RE: ENGINEER'S CERTIFICATION FOR MANZANO BAPTIST CHURCH
(L-22/D47) RECEIVED NOVEMBER 16, 1990

PROJECT TITLE: MANZANO BAPTIST CHURCH ZONE ATLAS/DRNG. FILE #: L-22/D47

RE: REVISED DRAINAGE PLAN FOR MANZANO BAPTIST CHURCH
(L-22/D47) REVISION DATED July 30, 1990

RE: DRAINAGE PLAN FOR MANZANO BAPTIST CHURCH
(L-22/D47) RECEIVED JULY 22, 1988

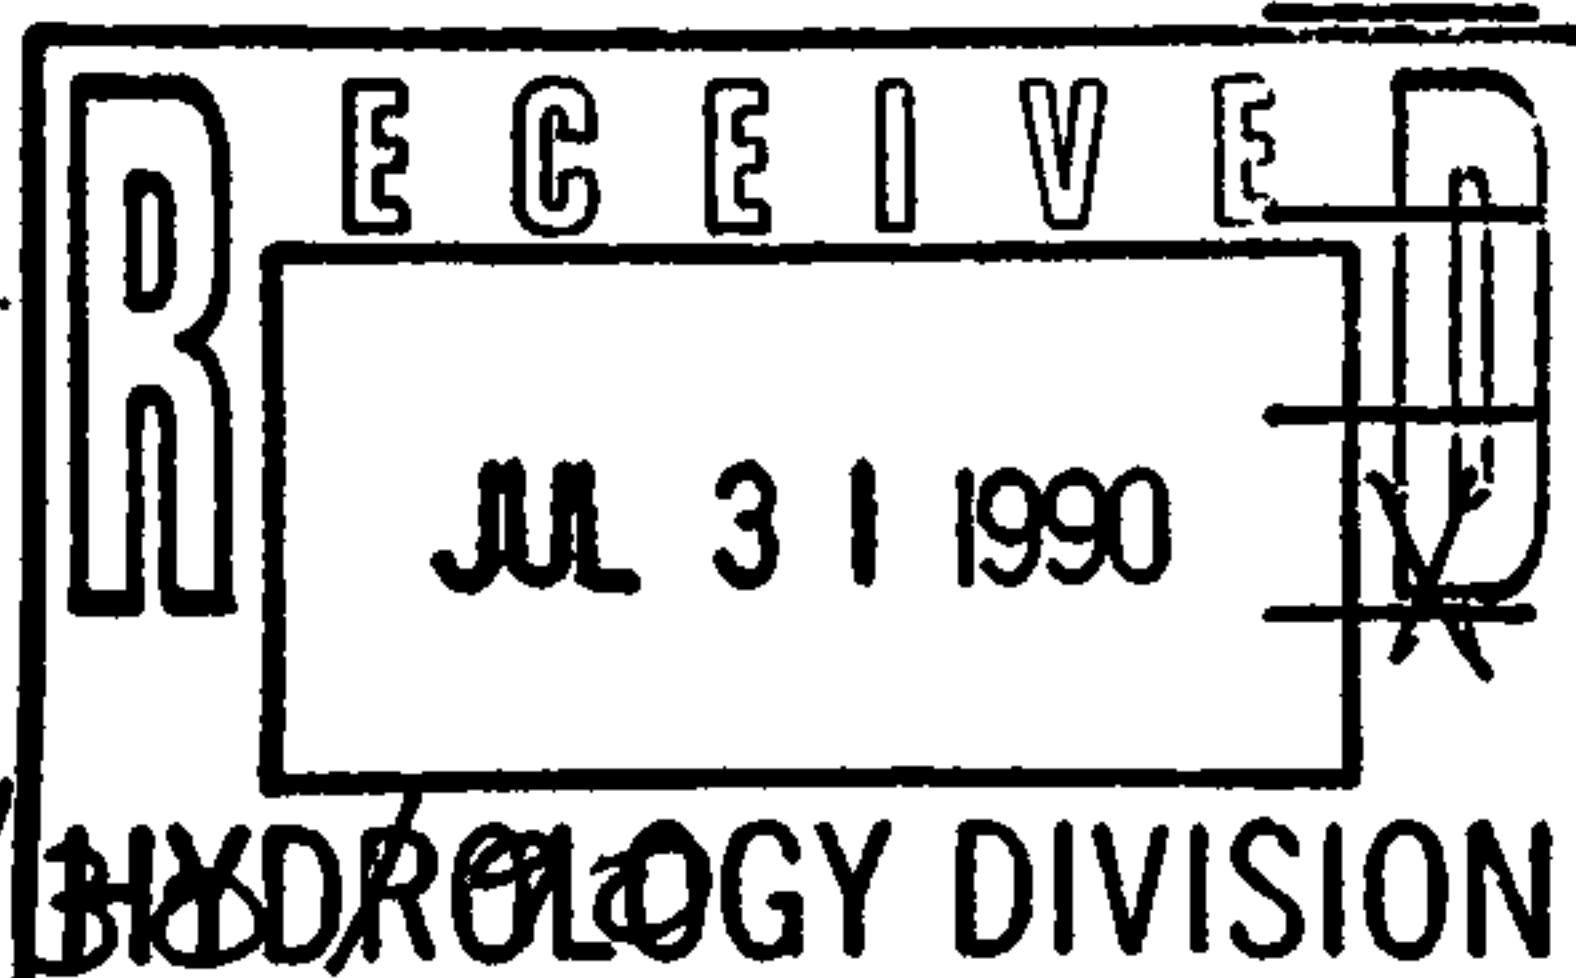
This resubmittal, with the addition of a sidewalk culvert at the
southwest corner of the site, is necessary because the contractor
did not grade the west portion of the site per the approved
drainage plan.

The proposed contours shown on the uphill slope reflect the as-
built conditions. The new swale shown at the bottom of the slope
will direct runoff to the new sidewalk culvert as shown hereon.

Based on the information provided on your resubmittal of July 31, 1990, revisions as indicated are acceptable.

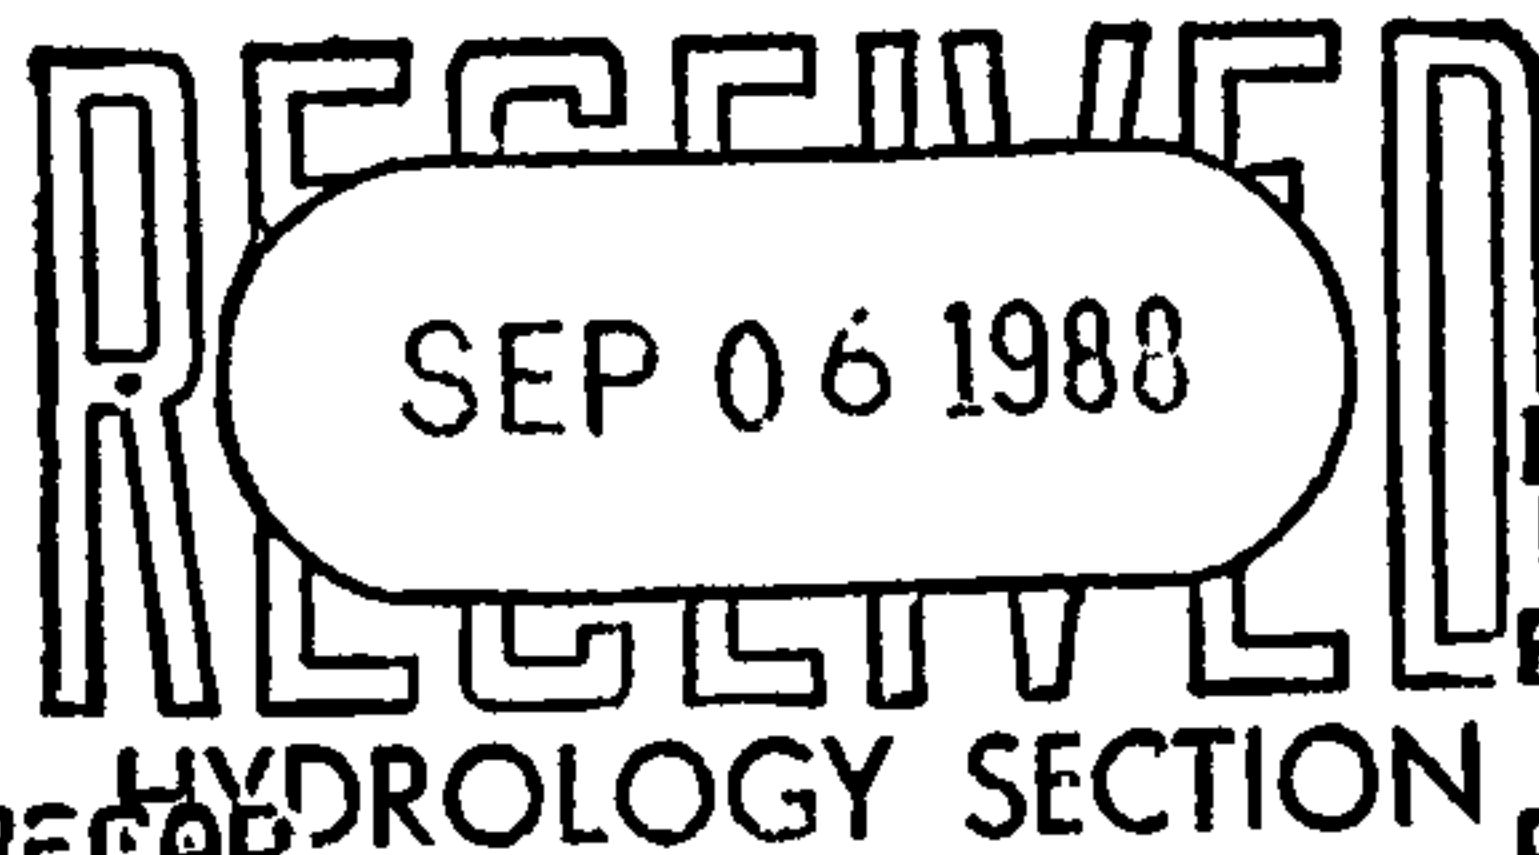
Alo, roof runoff must be routed towards the sidewalk culverts and not over the public sidewalk.

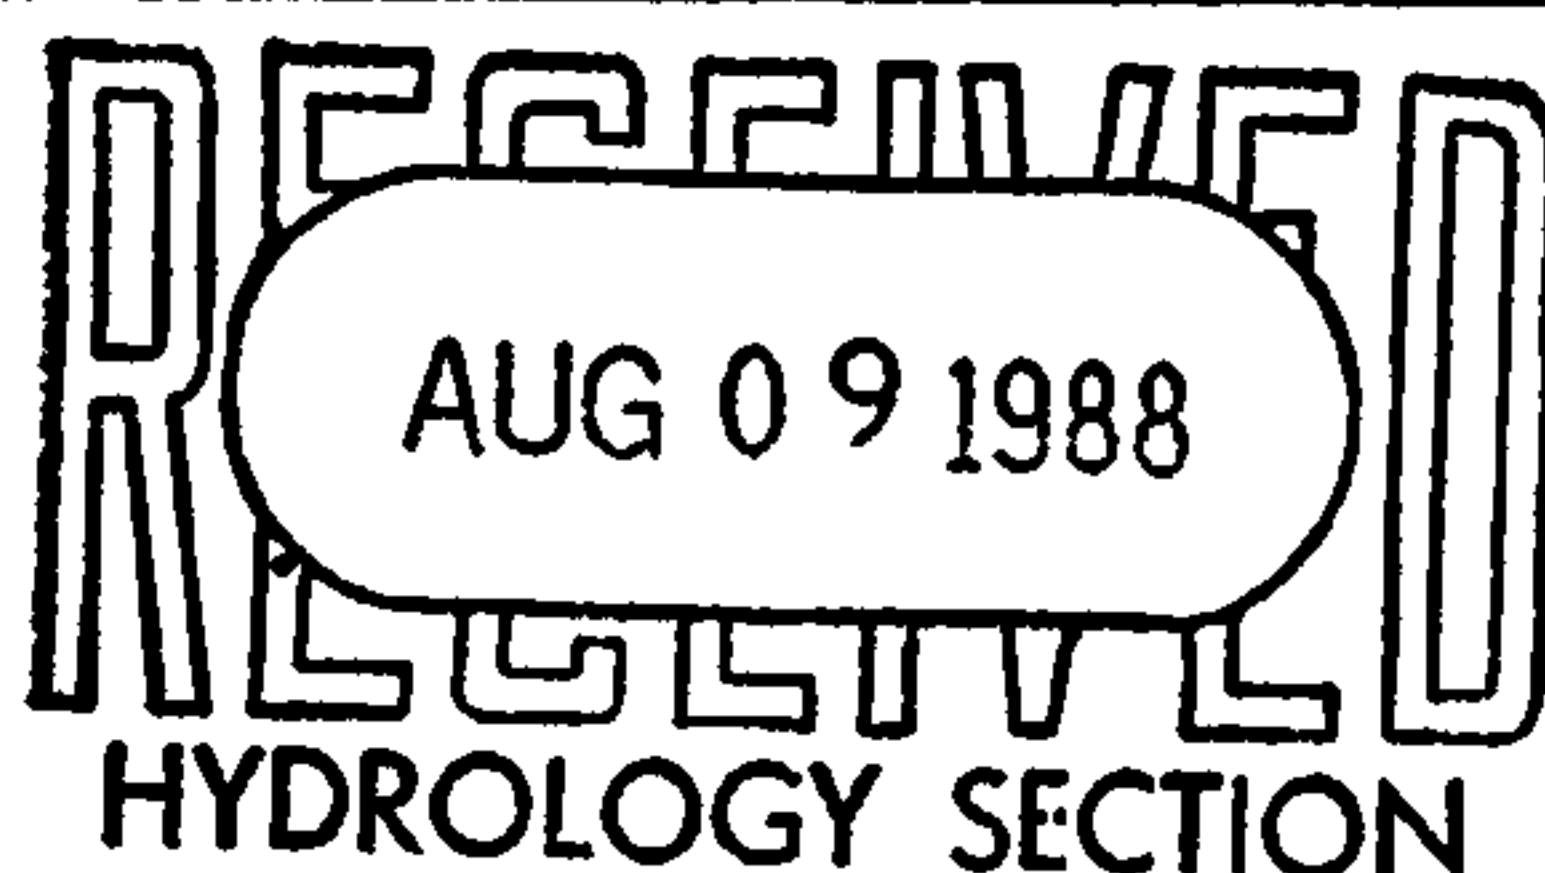
Based on the information provided on your resubmittal of August 9, 1988, there are still certain concerns that will need to be addressed prior to approval:

1. How do you propose to handle the 0.01 cfs of offsite flows? You cannot pond it on the proposed landscape area.
2. Roof runoff from the west side of the proposed addition has not been addressed yet. You must direct this runoff towards the asphalt area and not over the public sidewalk.
3. Construction notes along with the sign-off block from the S.O. #19 format must be included within the plan drawing.
4. Two copies will be required with the resubmittal.

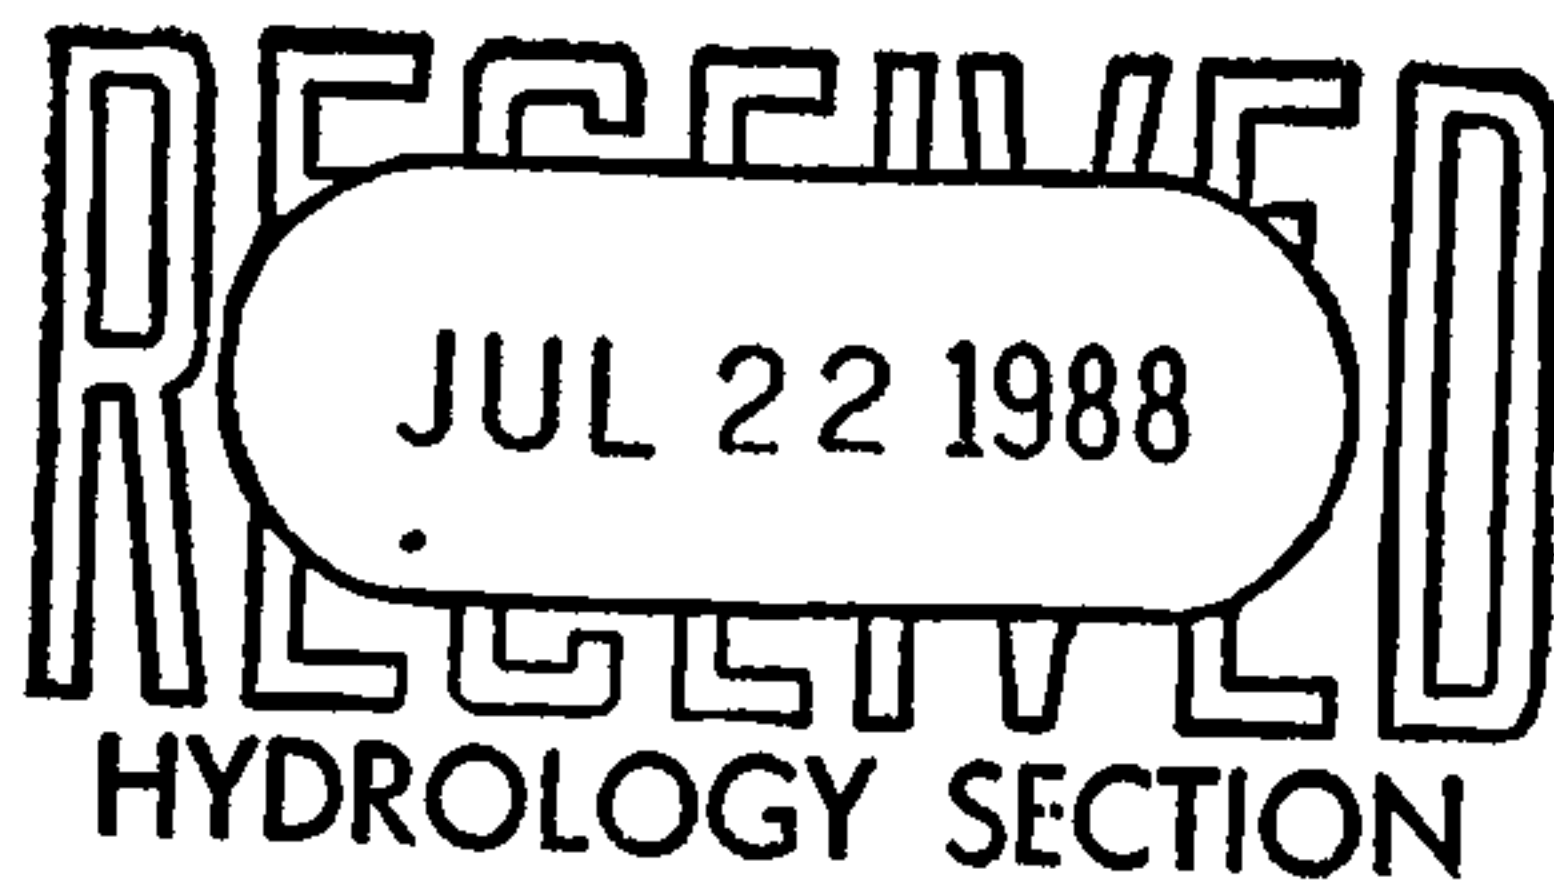
Based on the information provided on your submittal of July 22, 1988,
listed are six items that will need to be addressed prior to approval:

1. existing contours indicate you may have off-site flows entering the site at the northwest corner;
2. sidewalk culvert calculations will, will the proposed culvert release the developed 8.41 cfs?
3. roof run must be routed towards the asphalt area. How do you propose to accomplish these?
4. approved filed copy of replat submitted for our files;
5. engineer's stamp must also be dated;
6. water must be directed into the sidewalk culvert. Is the sidewalk going to be raised enough so as to keep the runoff from being directed elsewhere besides the sidewalk culvert?
